ADDENDUM NO. 04
 August 06, 2010

Project: **Package A – 2010: Misc. Renovations and Additions to Cook Middle School and E.L.C. No. 2**
 Cypress-Fairbanks Independent School District

Bay Project No.:0930 (10-02-2196R-FP)

PARTIAL SITE PLAN - 6/C1.01-CO

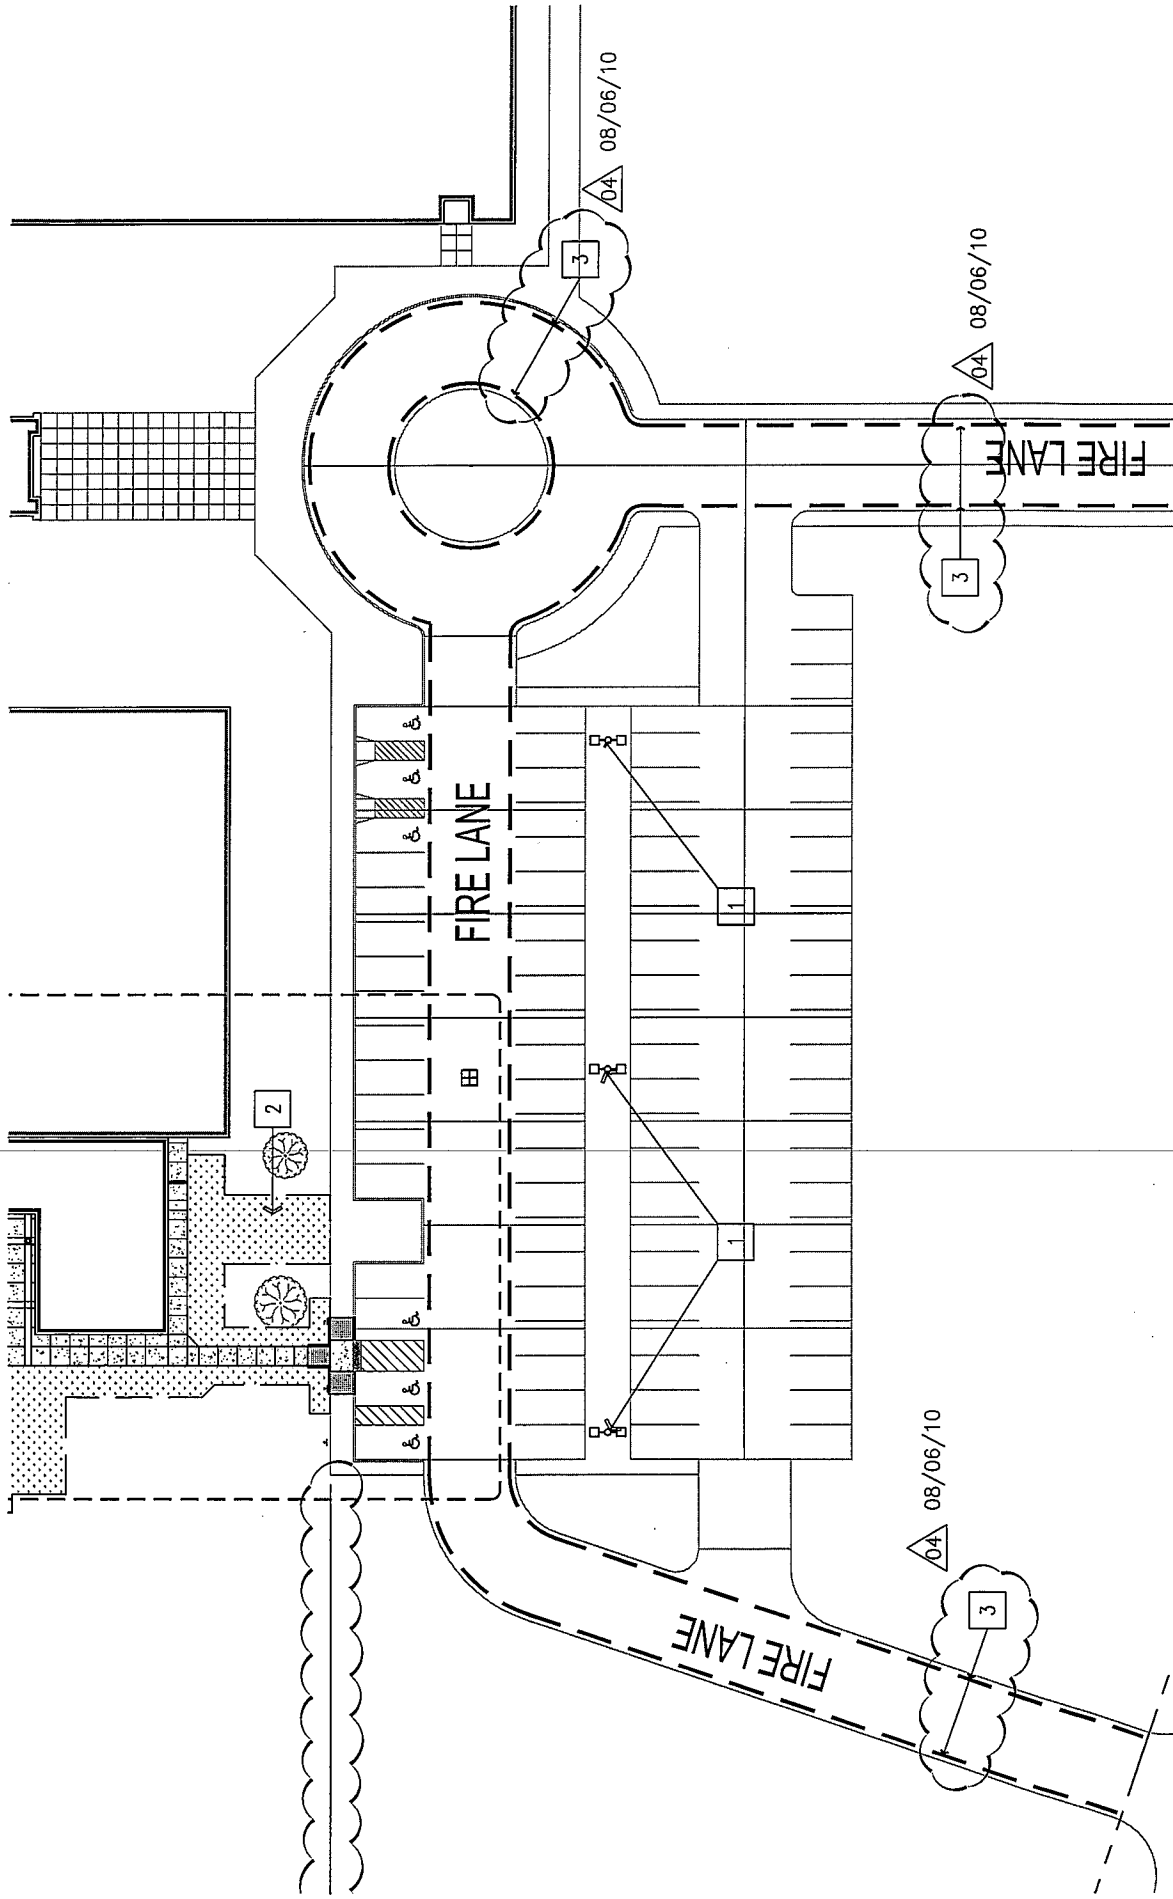
- c. Revise FIRE PROTECTION to read “SPRINKLER SYSTEM: NONE” in lieu of “SPRINKLER SYSTEM: AUTOMATIC SPRINKLER PROVIDED IN MUSIC”.
10. Sheet C1.01-co
 - a. Revise partial 6/C1.01-co SITE PLAN per attached sketches SK-ADD04-01 thru SK-ADD04-02.

PARTIAL RENOV. SITE PLAN - MECH. YARD - 3/C1.03-co

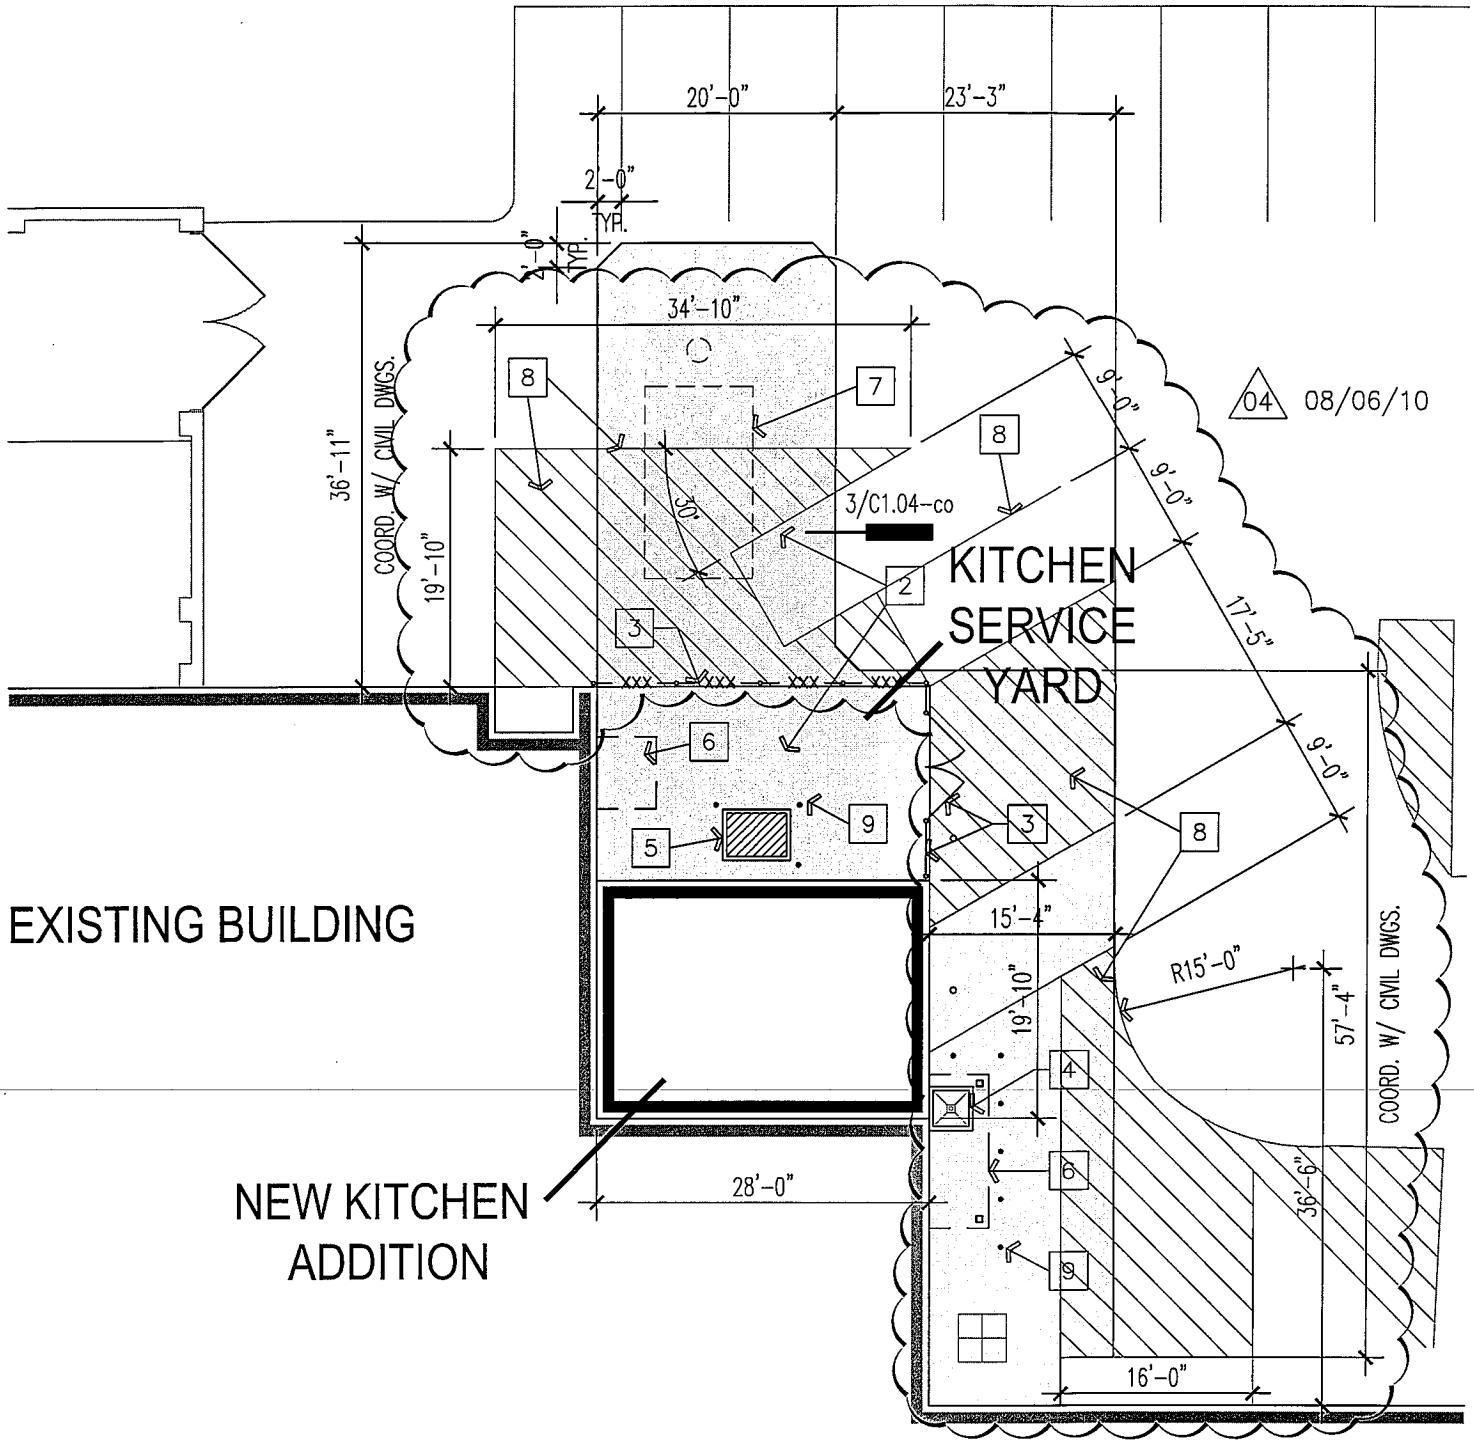
12. Sheet C1.03-co
 - a. Revise 3/C1.03-co PARTIAL RENOVATION SITE PLAN – MECHANICAL YARD per attached sketches SK-ADD04-03 and SK-ADD04-04.
 - b. Detail 6/C1.03-co PARTIAL RENOVATION SITE PLAN – FINE ARTS ADDITION, delete the extraneous leader near the existing grate inlet.

PARTIAL RENOV. SITE PLAN - FINE ARTS ADDITION - 6/C1.03-CO

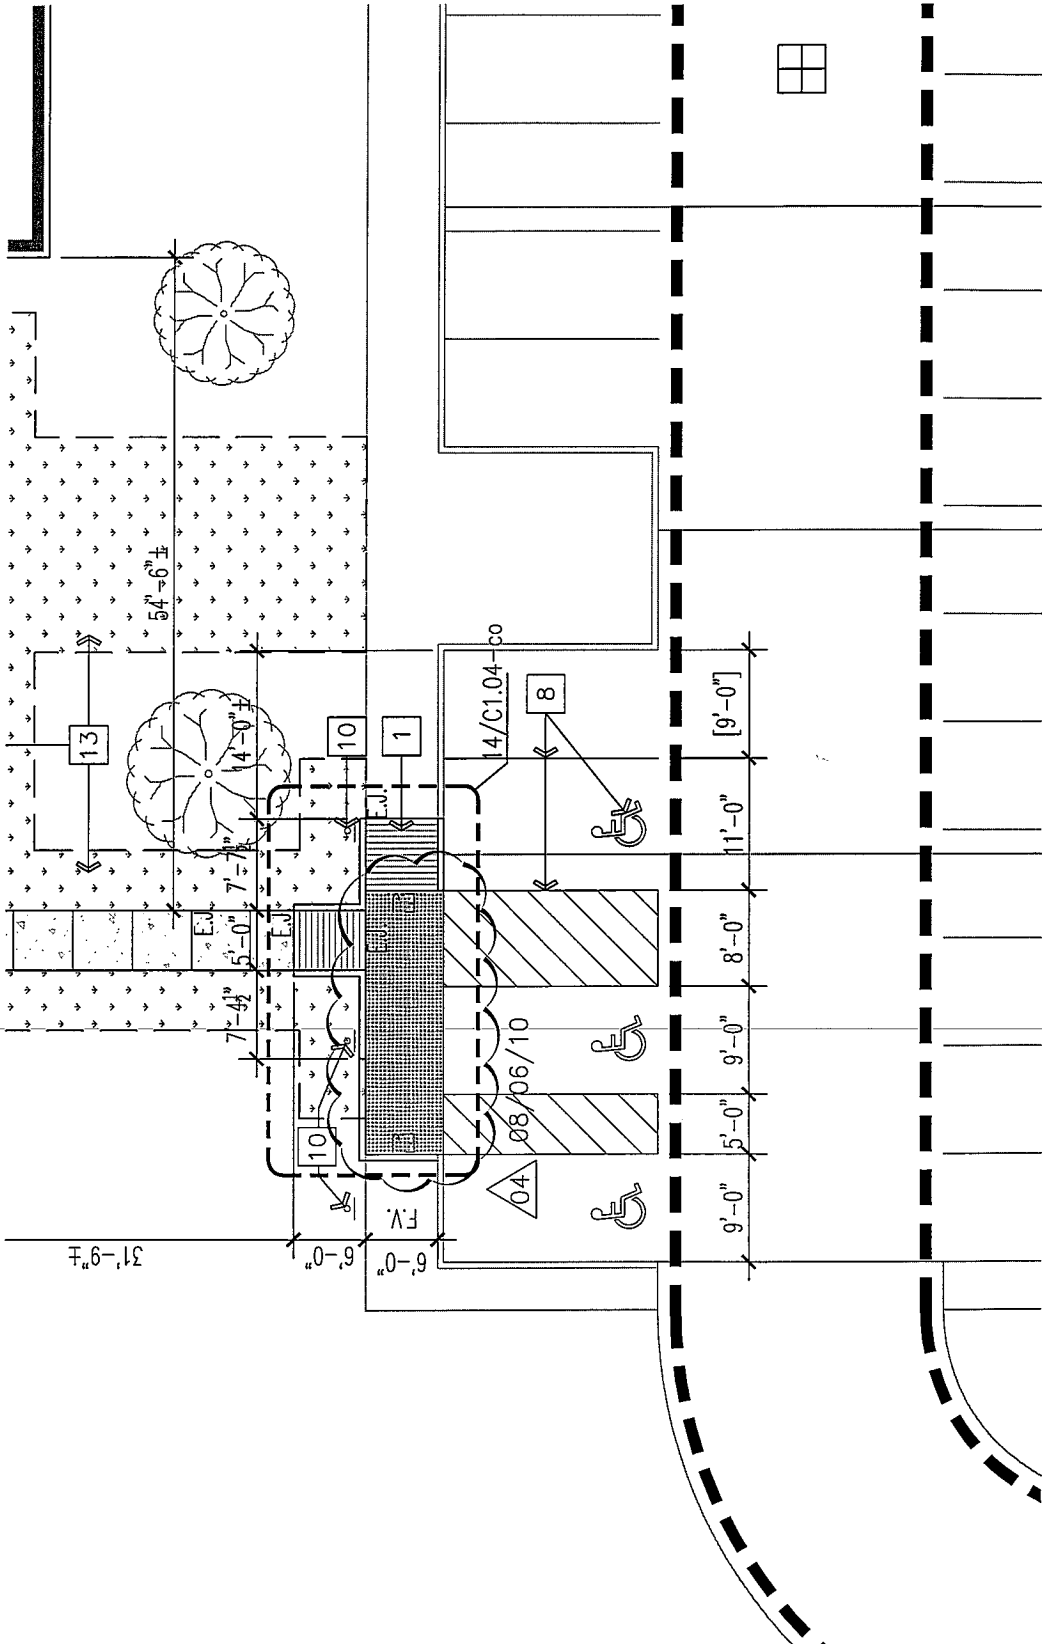
- c. Revise 6/C1.03-co PARTIAL RENOVATION SITE PLAN – FINE ARTS WING per attached sketch SK-ADD04-05.
 - d. Detail 13/C1.03-co SITE RENOV. KEYED NOTES, square Keyed Note No. 1, add the words “CROSS-SLOPES SHALL NOT EXCEED 1:50 AND SHALL MEET THE REQUIREMENTS OF BOTH T.A.S. & T.D.L.R.”
